RECONSTRUCT RUNWAY 4-22

TUSCALOOSA NATIONAL AIRPORT
TUSCALOOSA, ALABAMA

ADDENDUM No. 1

May 05, 2020

1 RUNWAY 4-22 PAVEMENT SECTION
SCALE: N.T.S.

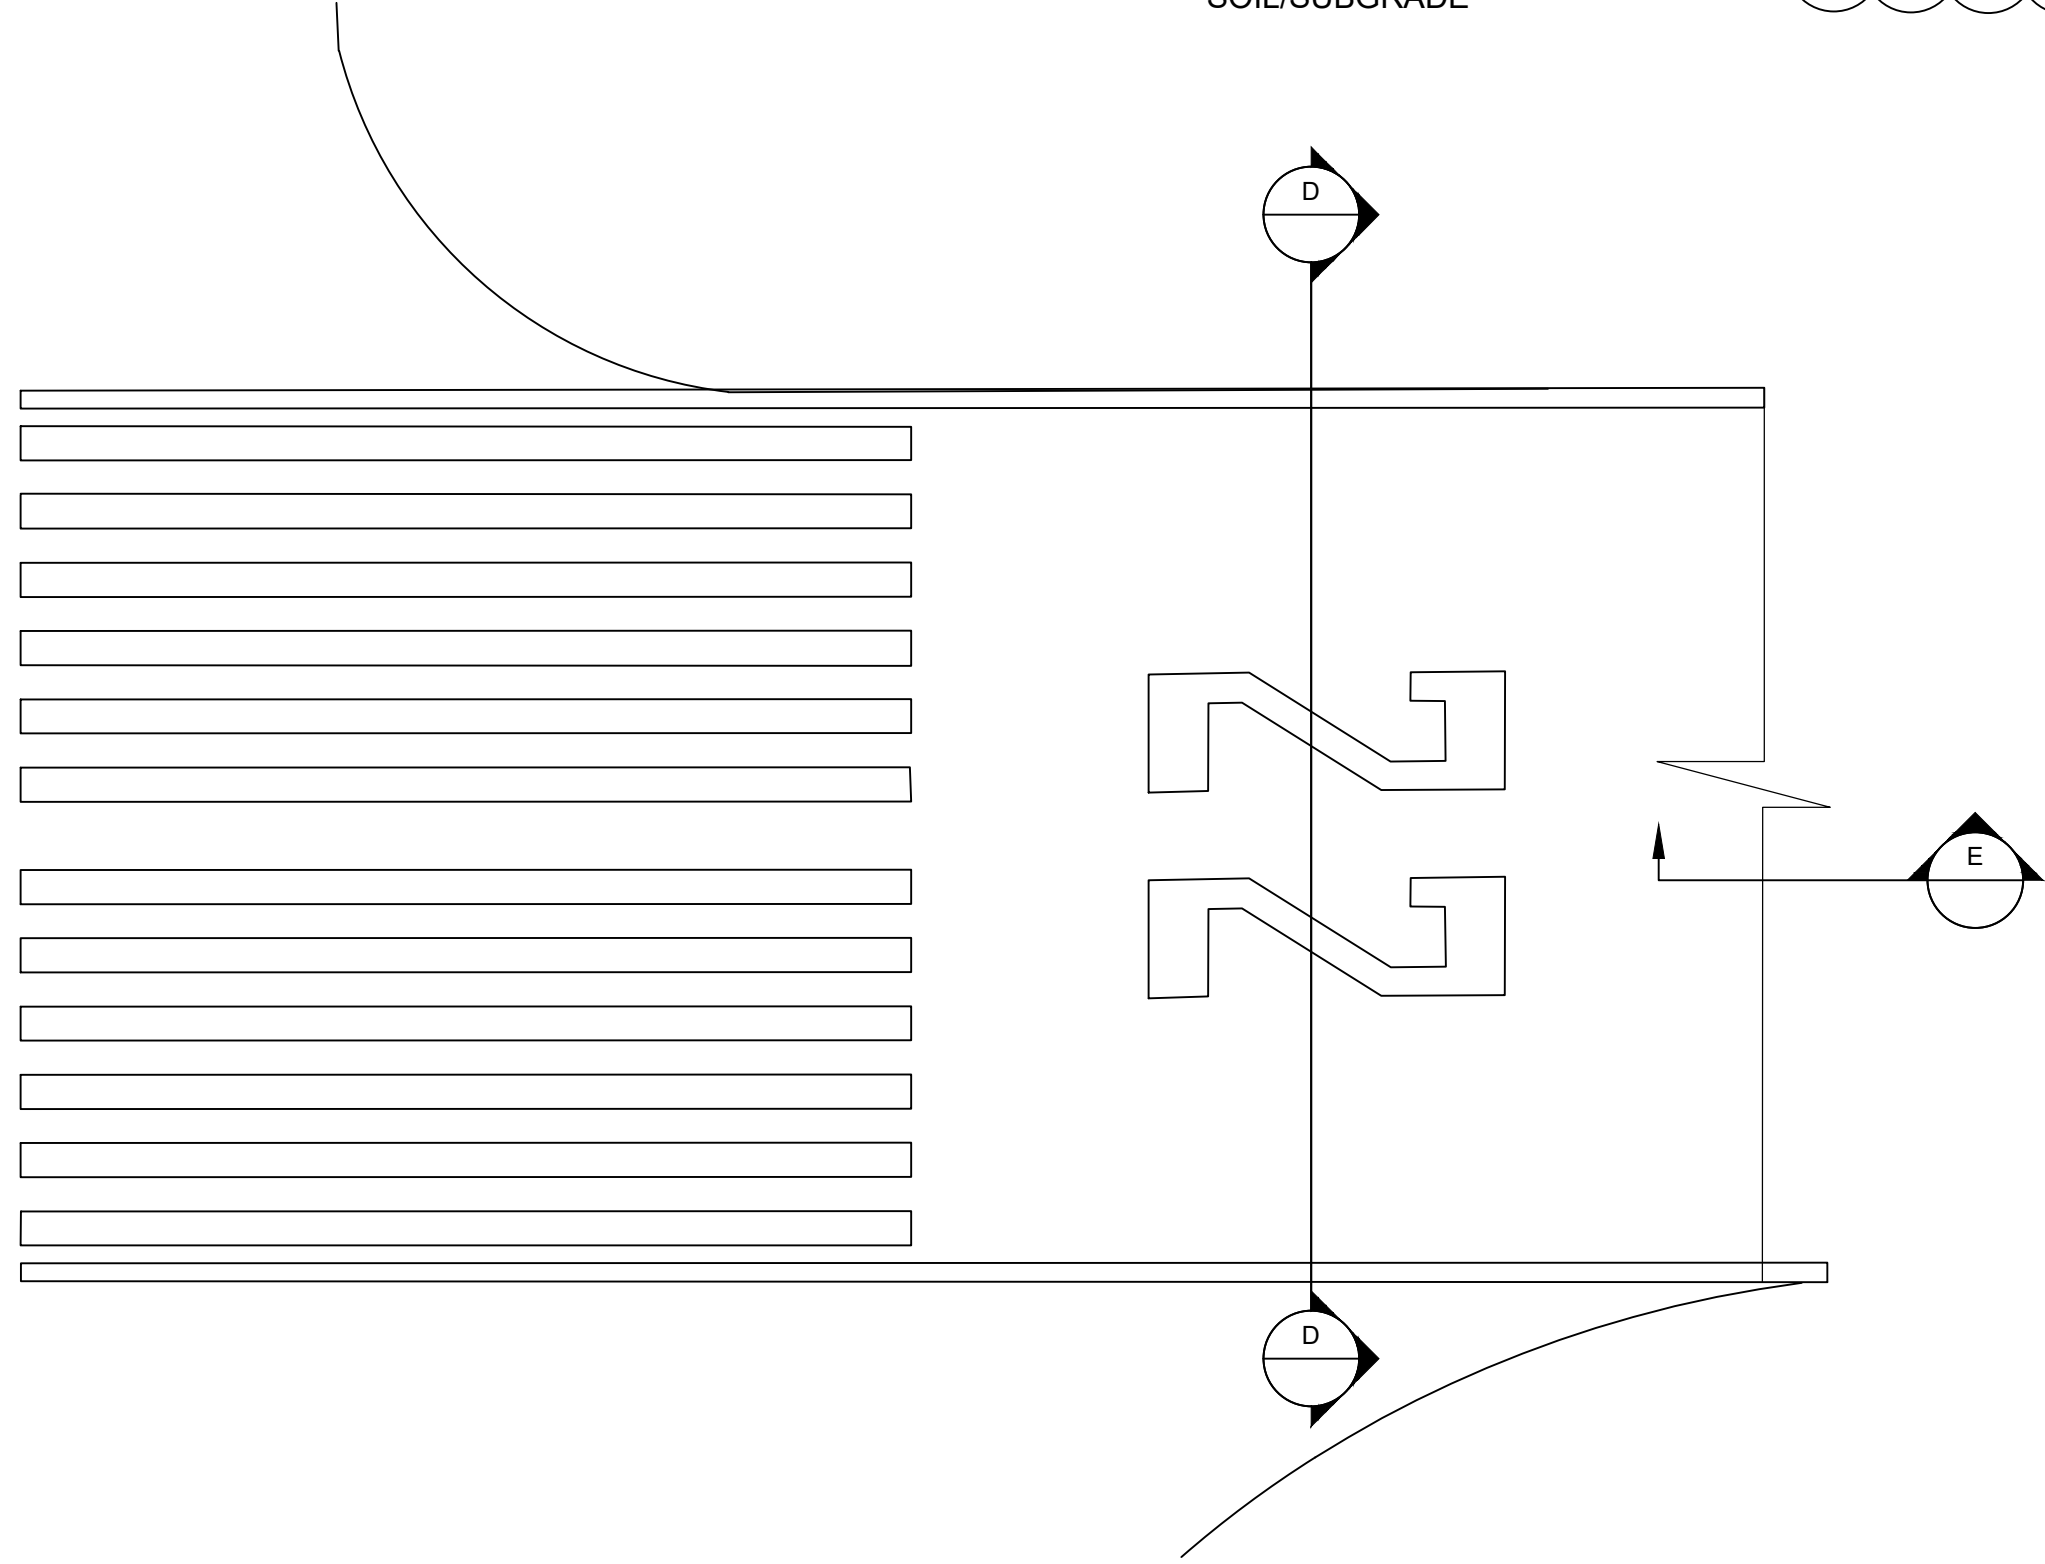
7. Sheet C-502, Miscellaneous Paving Details, **REPLACE** this sheet with the like-numbered sheet included with this transmittal. The purpose of this change is to revise Detail 1, Runway 4-22 Pavement Section so that it addresses two shoulder scenarios.

- This detail originally only addressed the scenario where pavement edges match closely to the existing turf shoulder elevations, and only a very narrow strip of turf adjacent to the pavement would need to be disturbed (less than 2 feet wide) suitable for exposing surface of the P-207 layer where it extends several inches beyond the surface paving limits for the FDR process. For this scenario, the 1.5 inch edge drop from the top of the outer edge of the pavement to the top of the topsoil layer is shown, and no sod is intended to be placed on these areas. Turf stabilization of these narrow areas of disturbance is intended to be accomplished with hydraulically applied seed and mulch.

- The detail has been modified to include depiction of a second scenario, where the plan view sheets in the C-200 and C-400 series indicate the need for more extensive shoulder grading. In these areas a 10-foot wide or greater width of sod is called for. For such areas where sod is to be installed, the detail now depicts the approximate thickness of the sod layer and points out that in these areas the top of the topsoil layer should be prepared to a lower elevation so that the desired 1.5” edge drop from the pavement surface will be achieved to the surface of the sod mat.

7. **QUESTION:** Detail C-502 shows 1.5” dropoff to topsoil. Should that be 1.5” dropoff to sod?

RESPONSE: Where the proposed shoulder elevations very closely match the existing surveyed turf shoulder elevations, no sholder grading is shown on the plans, and the the disturbed ground surface adjacent to the new pavement is expected to be very minimal—with a width between one and two feet—only as needed to prepare the outer limits of the P-207 base layer that will reach approximately 9 inches beyond the final proposed pavement edge. This is the extent of topsoil layer disturbance shown in the detail. In these areas, no sod is to be installed. Instead, the area is to be re-vegetated with hydraulically applied seed and mulch.

Where sod is to be installed on the shoulder as shown on the plans, the 1.5” dropoff shall be to the surface of the sod, and the prepared surface of topsoil shall be adjusted lower in order to accommodate the sod thickness.

The detail had originailly been drawn to apply only to the first of the two conditions described above, but it has now been modified to address both conditions.

| NO. | BY | DATE | ISSUED FOR | DESC. OF REVISIONS |
|-----|-----|------------|---------------------------|-------------------------------------|
| 1 | CDD | 4/29/2020 | 30% DESIGN REVIEW MEETING | ADDITION OF SOD CALLOUT TO DETAIL 1 |
